BOTLEY WEST SOLAR FARM (BWSF) REF: EN010147

Cumnor Parish Council - Comments for Deadline 7 on submissions received at Deadline 6

- 8.5. **Omission of the Hill End Outdoor Education Centre (an example of the omission of residencies in elevated positions to the north of the B4044, including the Oakenholt Care Home)**

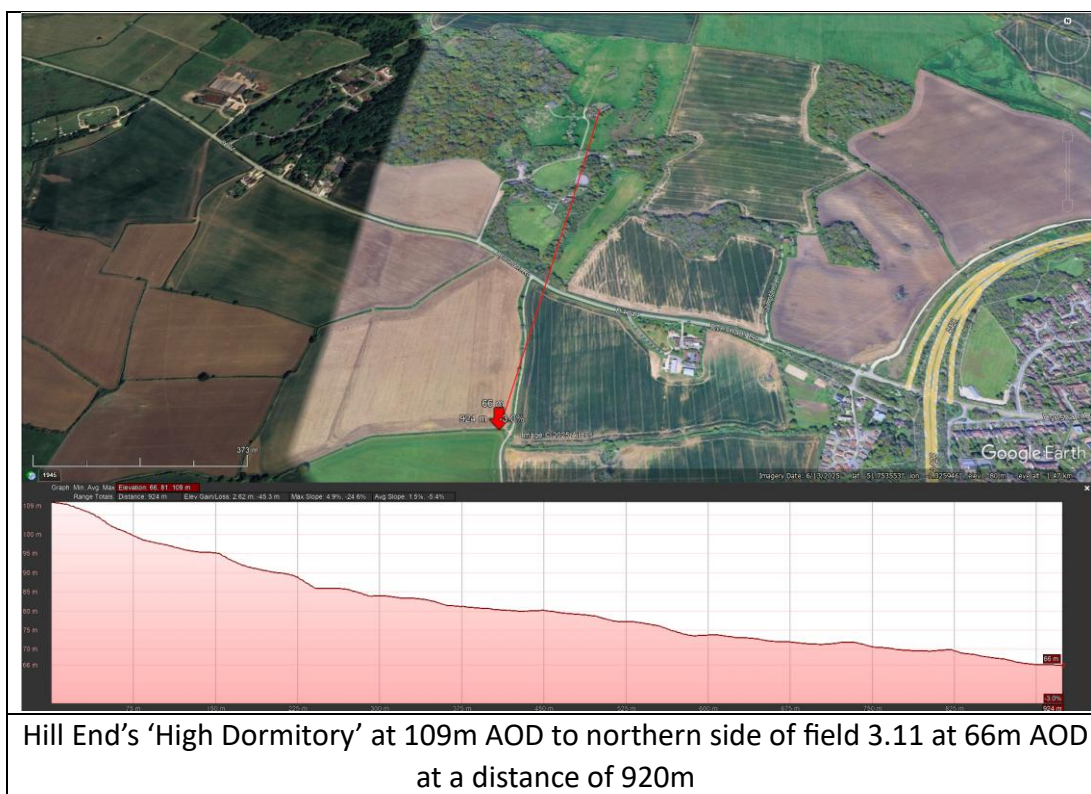
Hill End has been omitted entirely by the applicant in its RVAA assessment, not even featuring in the large-scale assessment maps in Figures 1.29 to 1.33 and 1.62 to 1.66 in REP6-064.

As CPC’s analysis of Google Earth (below) shows, the northern side of Field 3.11 sits at 66m AOD, some 43m below the 109m AOD elevation of Hill End’s famous High Dormitory², at a distance of 920m.

At its closest, the southern curtilage of Hill End is 396m from the northern side of Field 3.11.

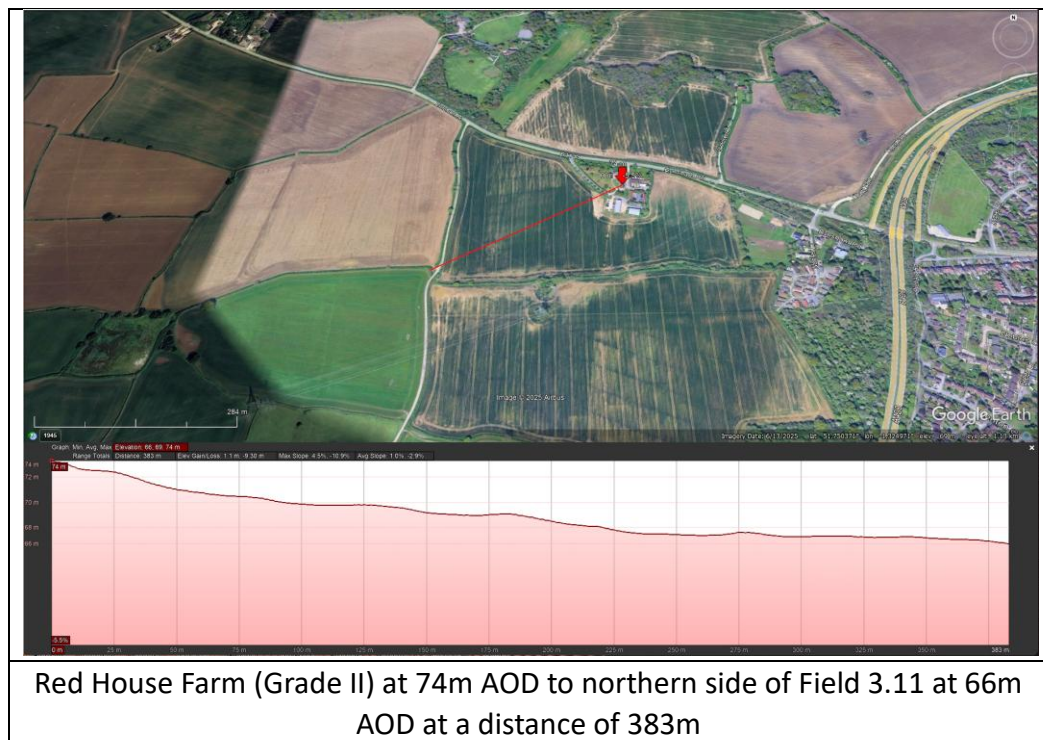
Given that all the 8 properties on the south side of Lower Whitley Road contain dwellings and gardens that face south towards Tumbledown, and that, for example, the 17th century Tumbledown Cottage (see list of Local Heritage Assets on page 76 of **REP1-057**) lies only 257m from the applicant's Field 3.3 (see page 52 of **REP6-118**) CPC concludes this is incontrovertible evidence of the scale of errors and omissions in the RVAA, which claims a '1km study area' (para 1.3.4 in **REP6-064**)

As the Google Earth snapshots (below) show, **Tumbledown Cottage** lies 11m below the northern junction of fields 3.6 and 3.8 at a distance of 729m, and 31m below the southern junction of fields 3.6 and 3.8 at a distance of 924m.

To again claim ‘invisibility’ as the applicant does, stretches CPC’s credulity and leads it to question the methodology actually undertaken during the belated RVAA, since CPC has provided this evidence by using Google, one of the tools listed by the applicant in their RVAA ‘methodology’.

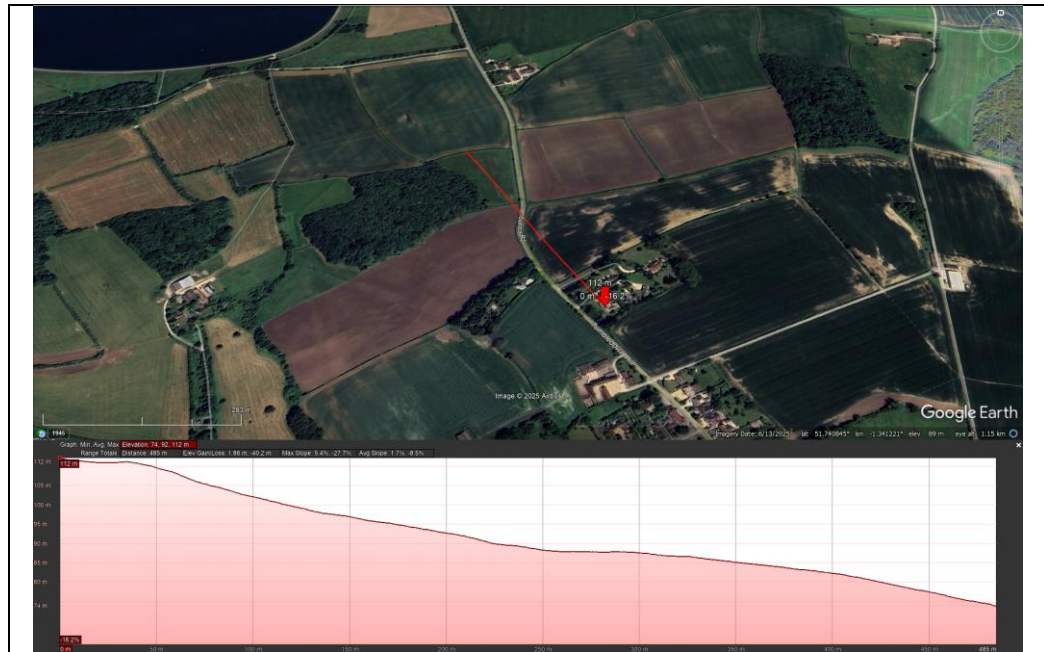
For example, **Wetherden (at w3w ///clockwork.rate.doses)** despite being categorised by the applicant as an '*other residential property*' is only 240m from the southern edge of Field 3.6.

Furthermore, at 112m AOD, Wetherden is 38m above the 74m AOD elevation of the southern edge of Field 3.3, at a distance of 480m and 45m above the northern edge of Field 3.3, which slopes S to N, at a distance 850m.

Wetherden (at w3w ///clockwork.rate.doses) at 112m AOD, some 38m above the 74m AOD elevation of the southern edge of Field 3.3, at a distance of 480m.

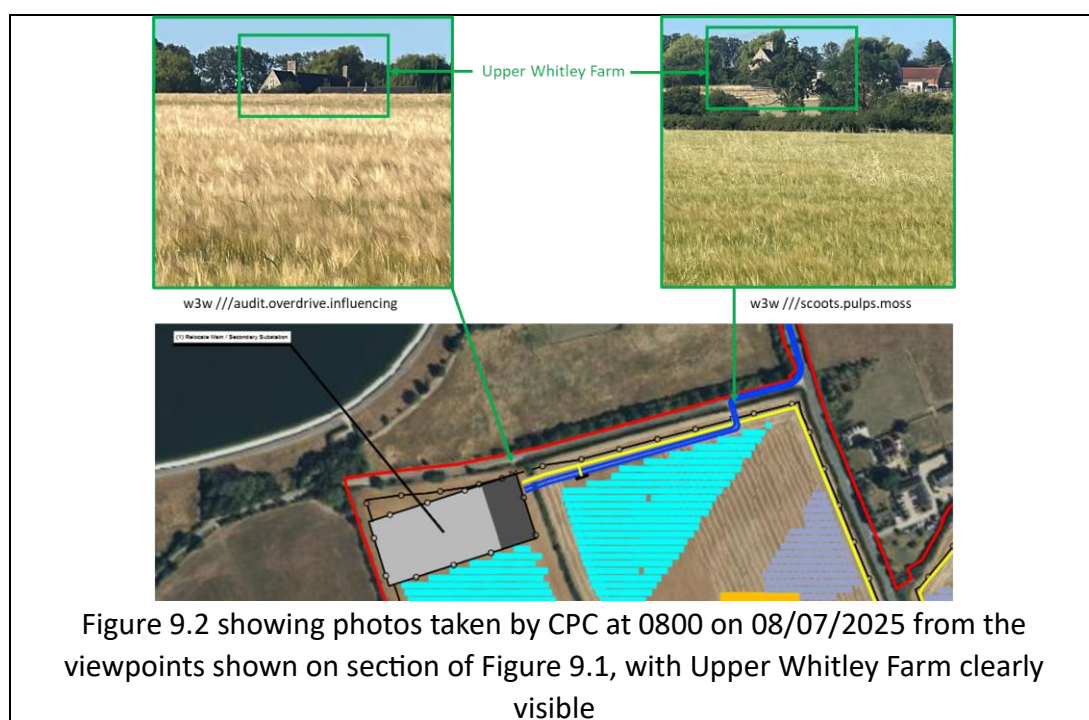
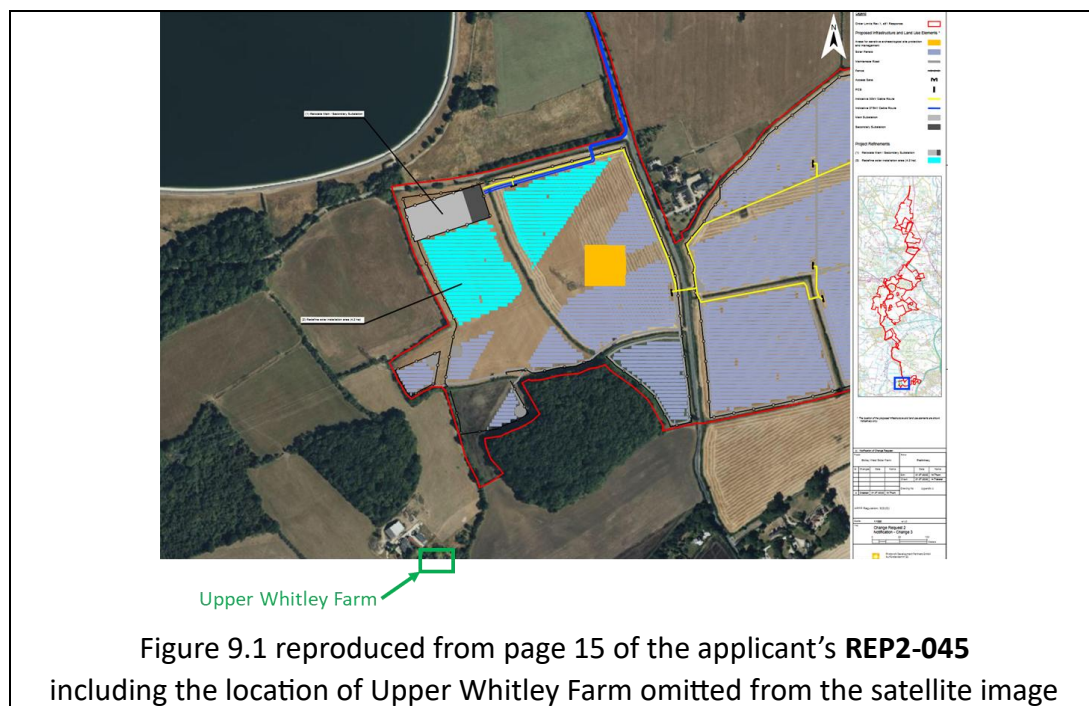
The residents of Wetherden wish the ExA to be aware that:

“The Residential Impact Assessment is at best inaccurate and at worst deliberately misleading. No attempt has been made by PVDP to assess the visual impact from Wetherden. The siting of the National Grid Power Station will have a major and significant impact on the visual amenity of this property. Unlike the solar panel installation, the impact will be permanent not temporary for 42 years. ”

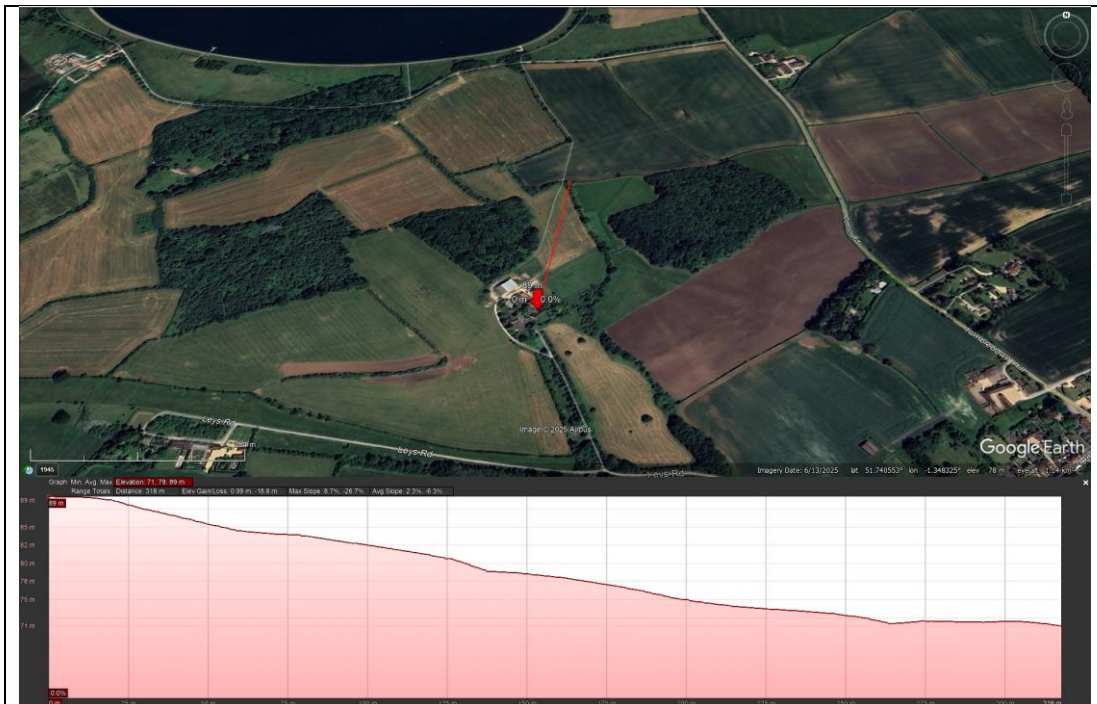
Despite the applicant's own Figures 1.32 and 1.65 in **REP6-064** listing both Upper Whitley Farm and Cedar Barn as '*residential property within the study area*' they are not taken forward into any RVAA.

As a reminder to the applicant, CPC demonstrated the visibility of both properties from field 3.3 in section 9 of its **REP3-078**, reproduced below for convenience.

Upper Whitley Farm/Cedar Barn at 89m AOD to Field 3.1 at 71m AOD at a distance of 315m

Upper Whitley Farm/Cedar Barn at 89m AOD to junction of Fields 3.1 and 3.3 at 64m AOD at a distance of 704m

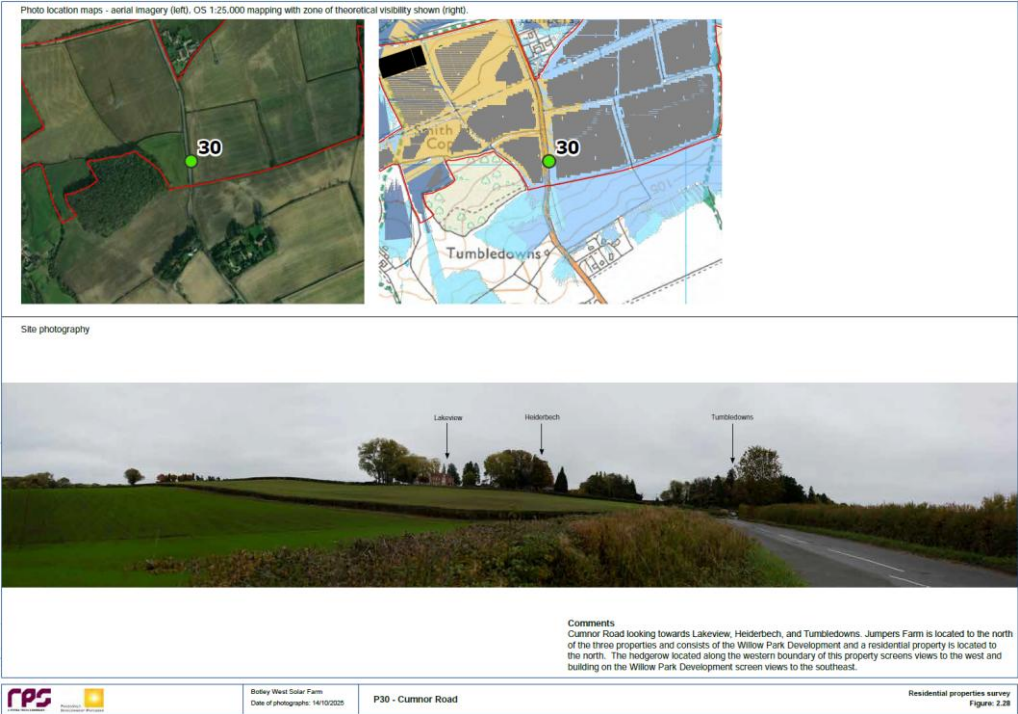
Taking first the case of **Heidersbach** and **Lake View**, the applicant clearly places great store in its Figure 2.27⁵ of **REP6-065** which depicts the entrances to the properties from the B4017.

Quite what this is meant to contribute to the RVAA assessment is unclear, save that – and perhaps the applicant hasn't fully appreciated the text of Landscape Institute Guidance Note 2/19 (as reported by the ExA in section 5 of **PD-018**) - it serves to amply illustrate the extensive curtilage of these properties.

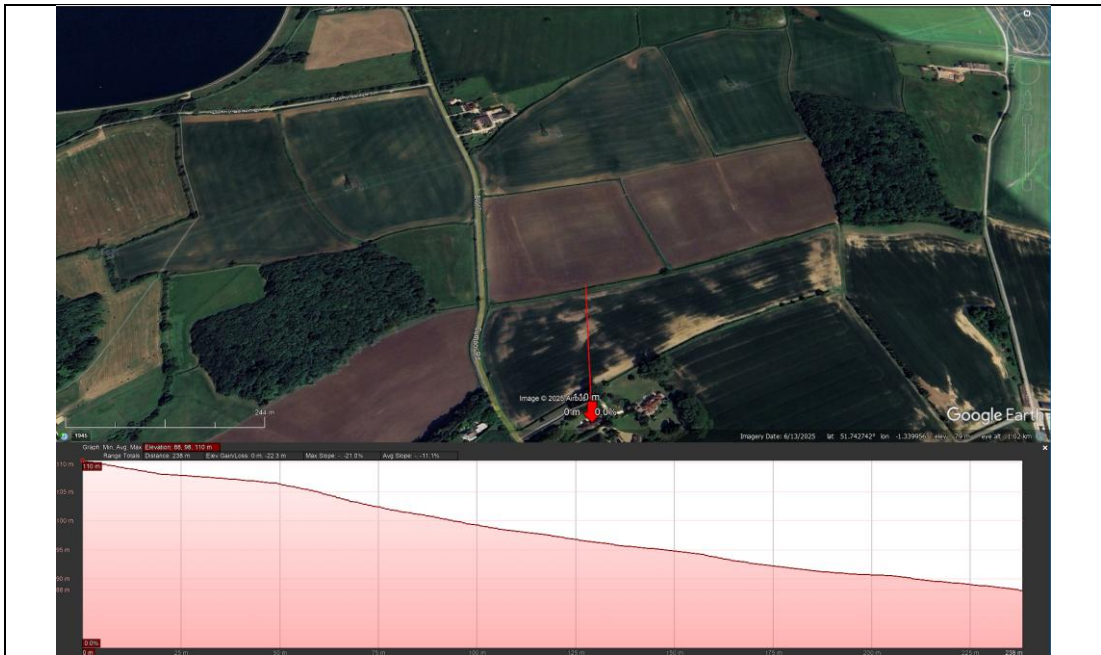
In contrast CPC offers the ExA a more methodologically sound way of accumulating evidence, using Google Earth data and photographs taken from the properties towards the applicant’s site.

Heidersbach is at 110m AOD, 22m above the 88m AOD elevation of the southern edge of Field 3.6, at a distance of 236m.

View from Heidersbach towards Fields 3.3, 3.4, 3.5 and 3.6

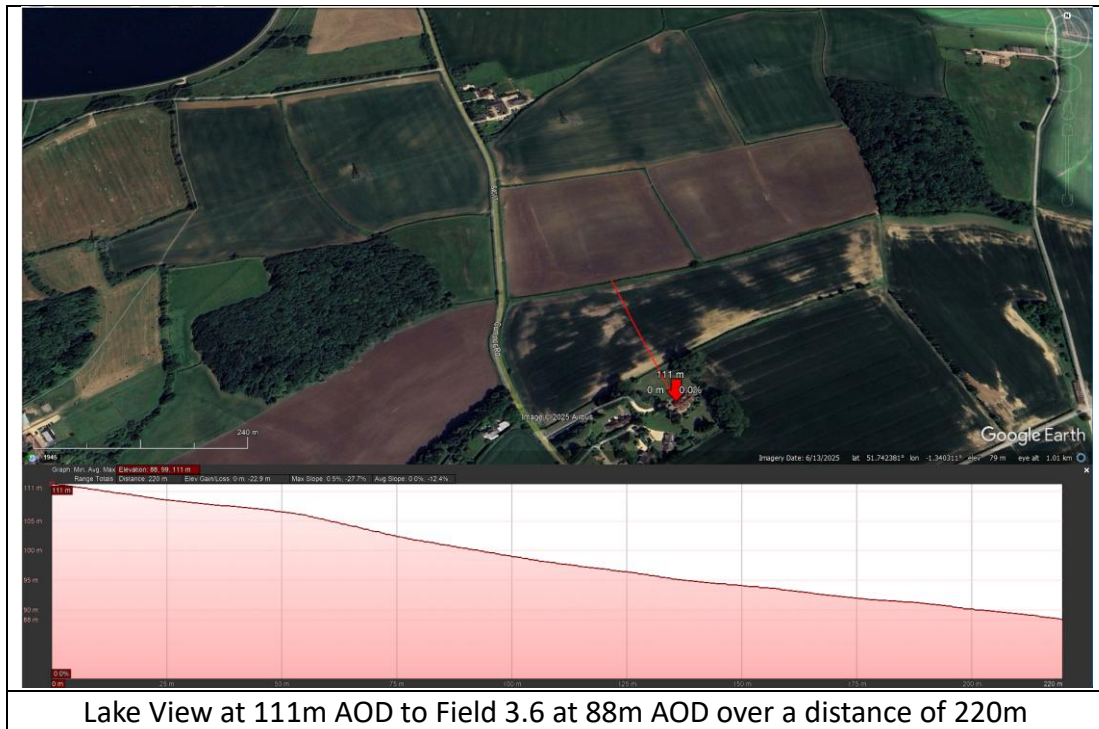
"I was disappointed and a bit shocked that after year of consultation and examination, the developers had not managed to find the time and make the effort to visit the properties that are most affected by the proposed solar power station development in the Farmoor valley.

I can't see how they could possibly have carried out any meaningful impact assessment without having done a site visit and spoken to the owners.

Being on the rim of valley about fifty metres higher than the proposed development, our house, like others, was built and orientated facing West of North to take best advantage of its commanding view over those areas where the development will take place. If this development were to proceed, the visual impact would be enormous, as can be clearly seen by anyone visiting the property. There would also be the problems of glint and glare, and noise.

Jumpers Farm at 66m AOD to northern junction of Fields 3.6 and 3.8 at 74m AOD over a distance of 309m (southern junction of 3.6 and 3.8 at 94m)

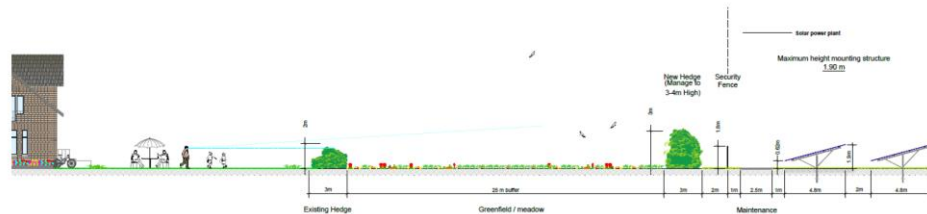
Jumpers Farm is at 66m AOD, 8m below the 74m AOD elevation of the northern junction of Fields 3.6 and 3.8 at a distance of 309m, and 28m below the 94m AOD elevation of the fields' southern junction.

Applicant's proposed mitigation method (above) vs real topography (bottom): Jumpers Farm curtilage at 66m AOD to Oxford Green Belt Way (184/15/30) at 96m AOD at a distance of 626m across Fields 3.5, 3.7 and 3.8

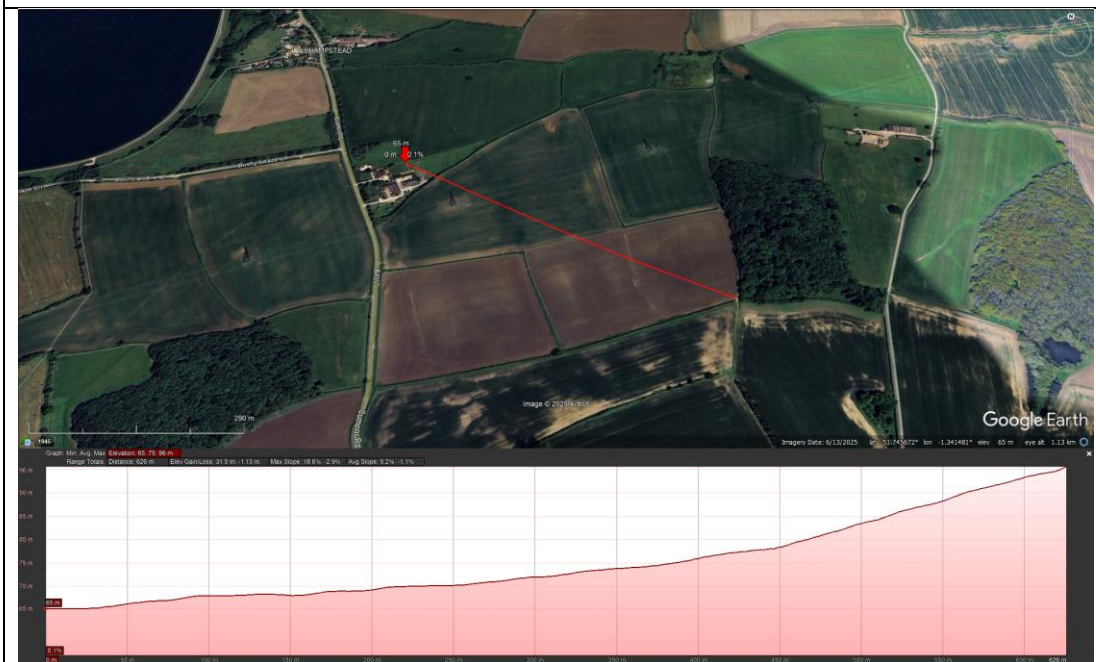
Jumpers Farm also illustrates the futility of the applicant's proposed mitigation method when applied real topographies that allow wide sweeping views.

3m-width-hedges **row (r1)** by the house's fence and **25m** of meadow between the next **row (r2)** of 3m-width-hedges followed by **2m** to the security **fence (f)**.

Unless the applicant is asserting that this property's '*dense vegetation*' (page 19-page 20 of **REP6-064**) is between 8m (74m AOD – 66m AOD) and 30m (96m – 66m) tall, and so obliterating all views from every part of the property and its curtilage, it is impossible to understand how it is possible to conclude '*minor not significant*' impacts.
